Report: TAB Punch-List
Function: Test, Adjust, & Balance
Date: 07/10/2025
Completed By: National TAB

Conner HS Fieldhouse (Hebron, KY)

Project: Conner HS Fieldhouse (Hebron, KY)

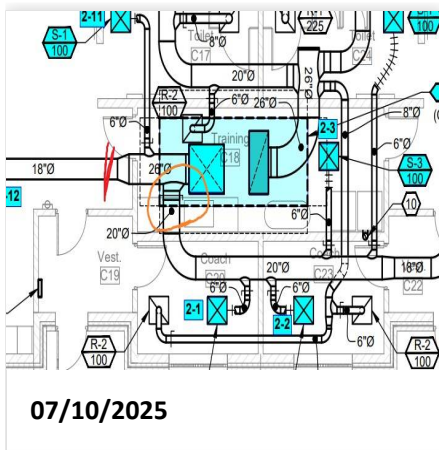
Issue Name : ERV 1 Exhaust Dampers
Description : Two exhaust grilles on ERV 1 are missing dampers. Unable to distribute flow to other individual grilles.
Created By : National TAB **Assigned To :** National TAB - Nick Payne
Status : Open
Priority : Medium **Asset Tag :**
Originated Date : 07/10/2025 - Gabe Merk - National TAB
